**RENOVATION OF THE KHANDEK
INTERMEDIATE SCHOOL
UNDER THE ECONOMIC SUPPORT FUND PROGRAM
YOUSEFIYA, IRAQ**

SUSTAINMENT ASSESSMENT

**SIGIR PA-08-136
APRIL 21, 2009**

Figure 2. Septic tank section (Courtesy of GRC)

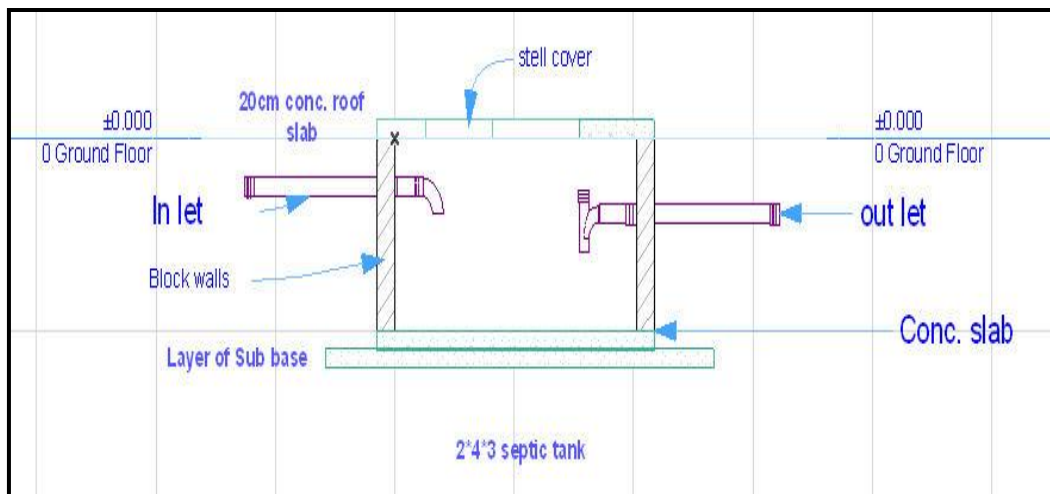
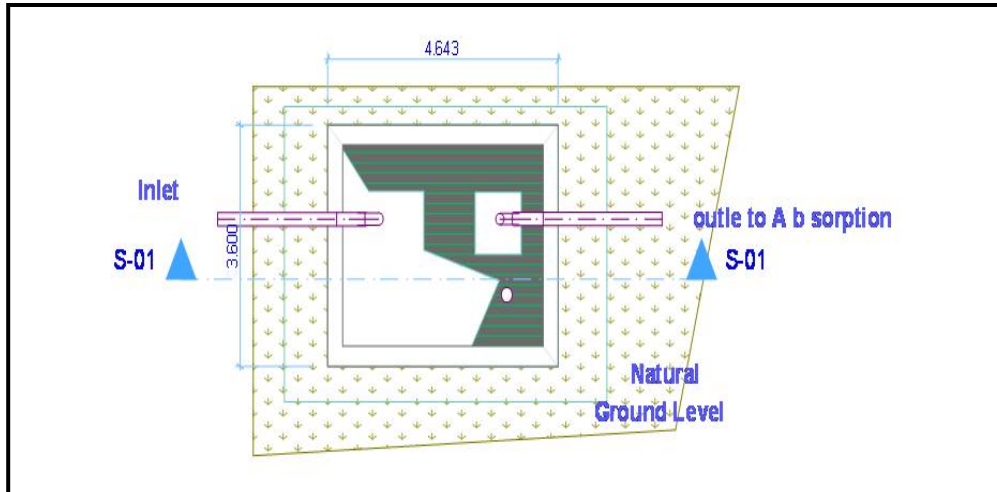
The septic holding tank indicates that the outlet of the tank flows to an absorption area. The location and configuration of the absorption was not indicated in the design. It is unclear if this system is intended to treat sewage and promote absorption into the soil, or if the tank(s) function as holding tanks to be pumped out on a regular basis.

Site Photo 6. Missing window screen

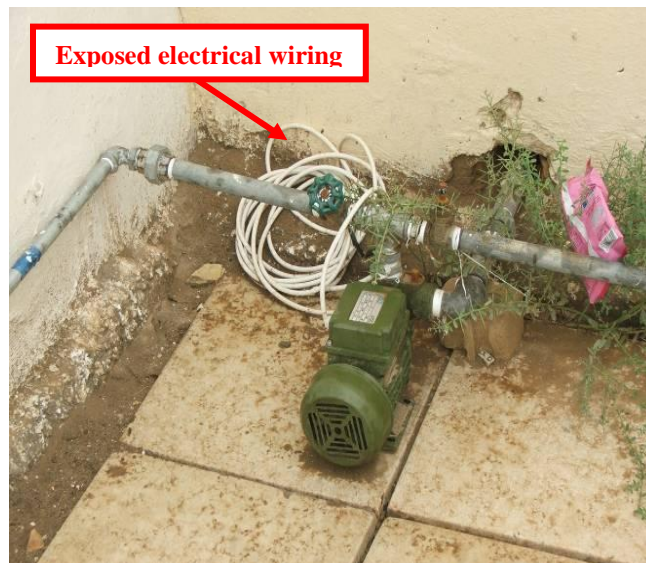
The new steel exterior doors and hardware were installed and functioning. The window glazing appeared to be in-tact. The windows have been painted and latching hardware has been installed. SIGIR did not observe any of the BOQ required window screens (Site Photo 6).

1. Ensure that the cracking and deflection of the reinforced concrete beam along the front of the new restroom facility does not present a safety hazard.
2. Anchor the water-supply pump to a support and enclose wiring to the potable water-supply pump in conduit.
3. Provide the window screens required in the contract.

Site Photo 8. New latrine building with significant shear crack

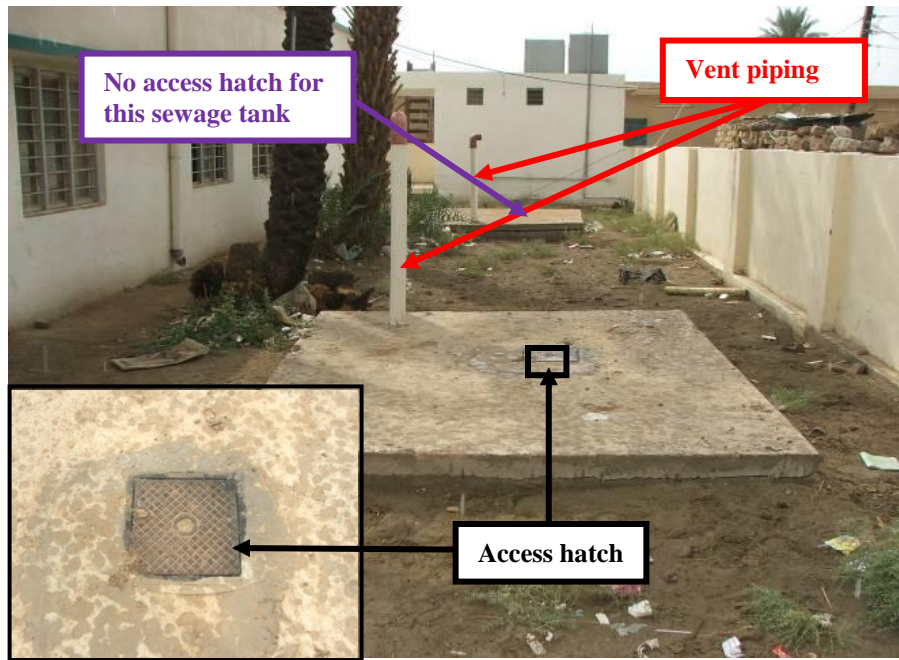
A new septic tank was constructed along with the new latrine. SIGIR identified a significant shear crack in the main beam along the front edge of the roof on the new latrine building (Site Photo 8).

Concur with all recommendations. The Gulf Region Central will require the contractor to take the actions outlined in the recommendations.

Site Photo 10. Septic holding tanks and tank access for one (lower left corner)

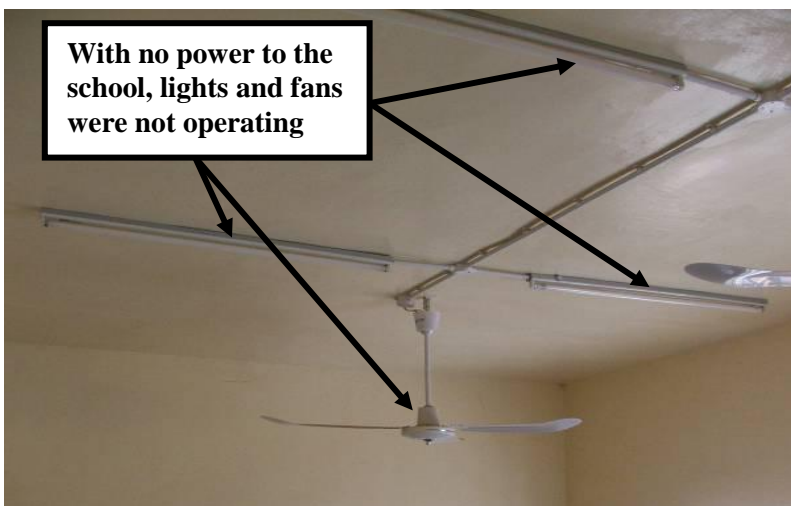
Two septic tanks were constructed on the site to service the two latrines (Site Photo 10). Vent piping was installed in the top slab of the tanks. SIGIR examined the tanks' top slabs, which did not exhibit any cracking or signs of failure; however, there was moderate curling of the top slab. A small access was provided for one of the tanks, which could be used for inspection and pumping; however, there was no access provided for the second tank. SIGIR believes this presents the school with future maintenance problems, since the school will be unable to fully empty the tank and residue will accumulate at the tank's bottom.

The contractor agreed to install an access hatch for the new sewage tank. GRC representatives verified that the contractor did install an access hatch (Site Photo 14). This access hatch will allow the school to periodically empty the tank so that residue will not accumulate at the tank's bottom.

Figure 4. Contractor's site plan submittal clearly showing the construction of a new water closet (latrine building) (Courtesy of GRC)

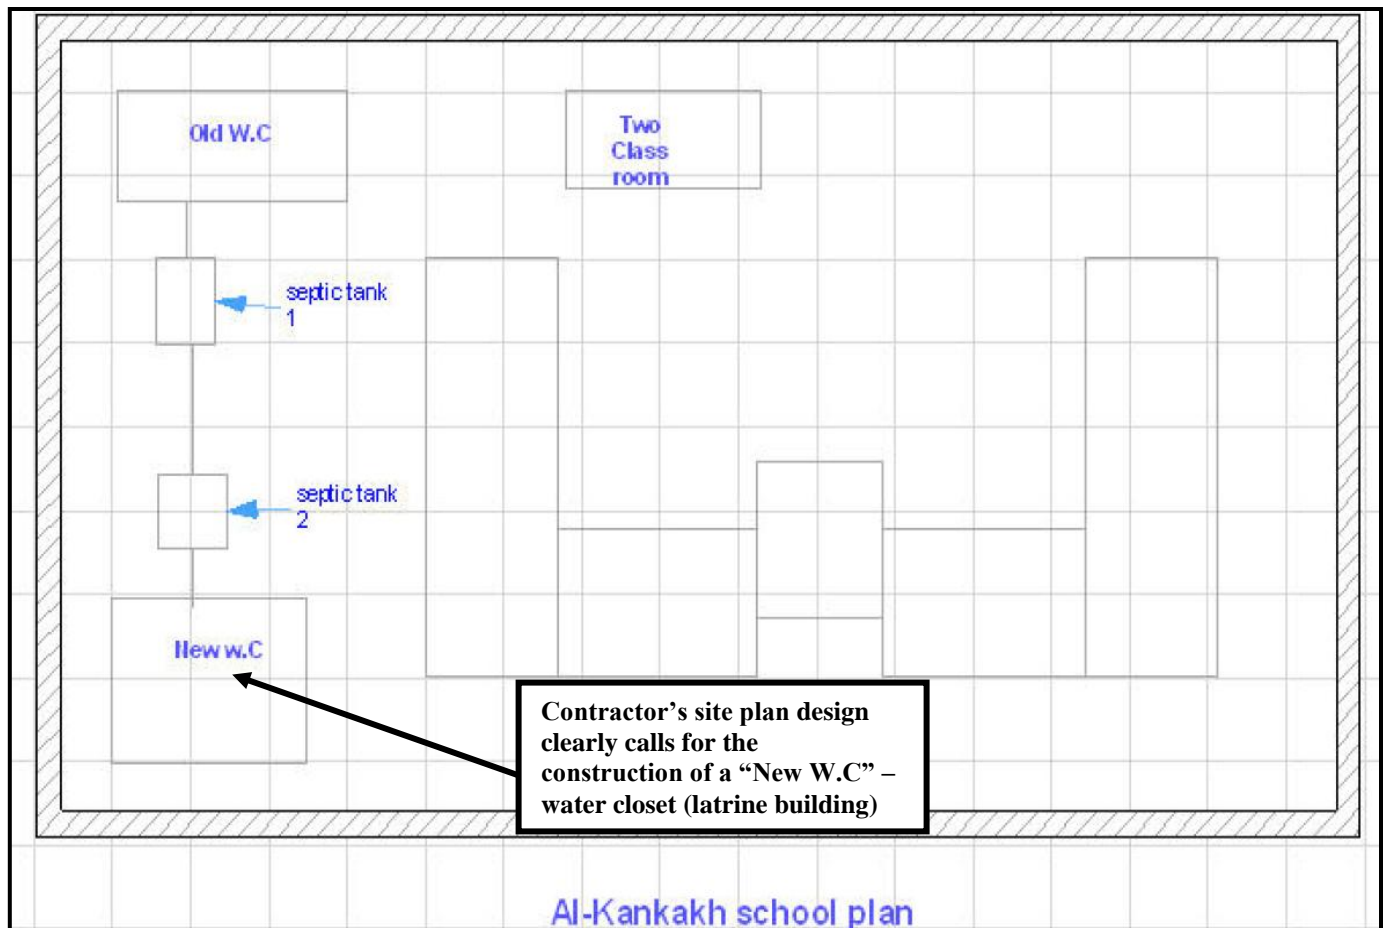
However, this statement is contradicted by the contractor's design submittals, which clearly indicated on the school's site plan "New W.C. [water closet]" (Figure 4). The design, which the contractor submitted to GRC for review and approval prior to construction, refutes the statement that this water closet/latrine building was the idea of the school master and not part of this contract.
